Permit Number HS000782

Onsite Wastewater Treatment System Request for Site Clearance and Permit

*Preliminary Design - Lagoon/Pond Lot # 2, Whitetail Ridge, 1st Addition

OPTION "B" Construct New Lagoon/Pond

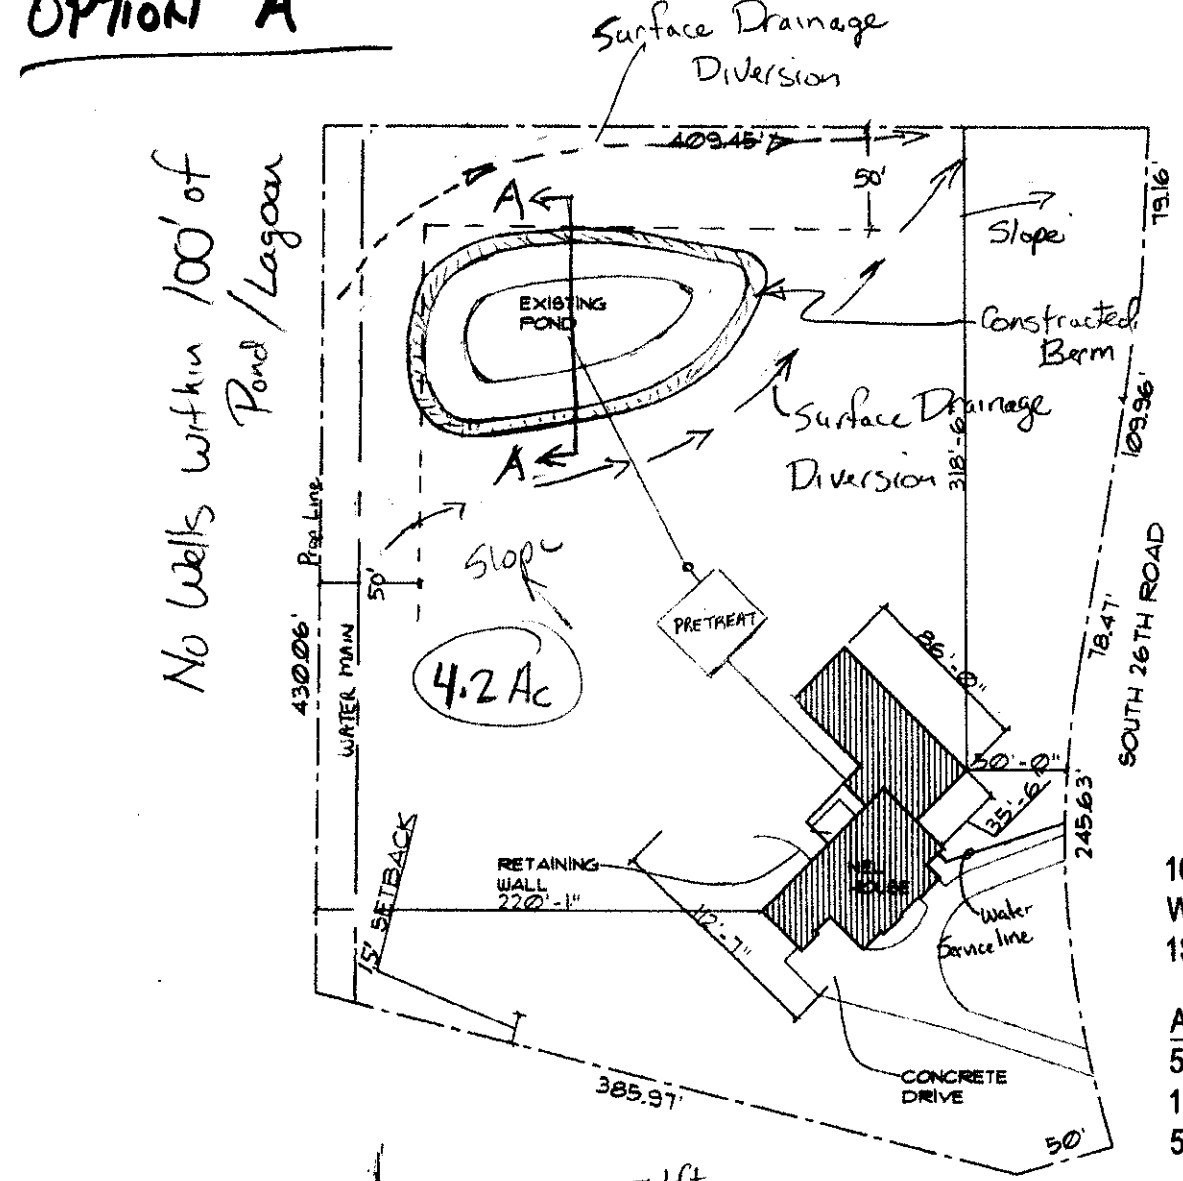
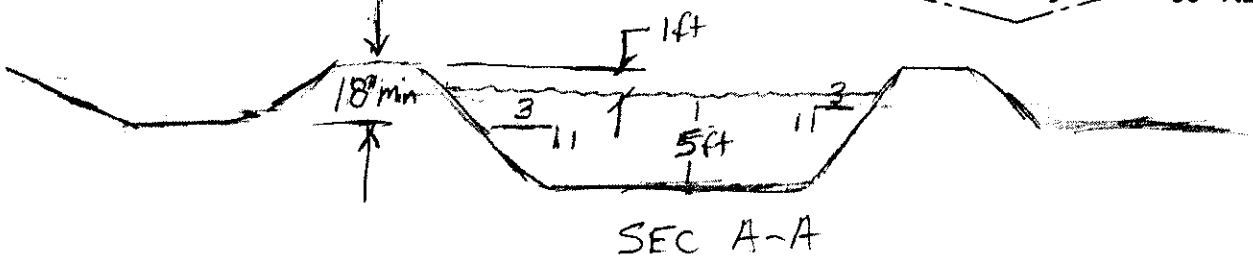
Just to clarify - Size (over 1,000 gpd) is just one Title 124 permit trigger (Ch.3). Non-domestic is another and the Title 124 requirements for permitting also apply if the prescribed requirements for "Authorization by Rule" are not met. Fencing is a specified requirement in Title 124 so if no fencing is planned that would also trigger the permit requirement. Thanks.

Attached is a file showing (2) options I am looking at for the lagoon/polishing pond. After closer review of the regs pertaining to lagoons, Option "B" would best fit the requirements for a lagoon in meeting all the setback requirements of Title 124. To be a bit conservative, I have shown a 12,000 s.f. lagoon. We will be submitting a plan to pretreat and disinfect the effluent with NDEQ to have the ability to eliminate the fencing requirements, not for the size of the system. In my conversations with Gary Buttermore and reading Title 124, a lagoon is permissible for a 9-bedroom home (1000 gpd peak, 825 avg design) without a NDEQ permit. 1001 gallons would require the permit.

Thanks for the clarification. It is our intent to apply for a permit to pretreat and disinfect to possibly eliminate the fencing requirement, as was achieved with the NDEQ Facility Number 78760 example you had sent me. If for some reason that is not possible or the home owner choose not to pretreat and disinfect, I wanted to make sure there was adequate room to construct a standard lagoon with required fencing. I also wanted to clarify that the same impoundment structure could be used as either a lagoon or non-discharging polishing pond.
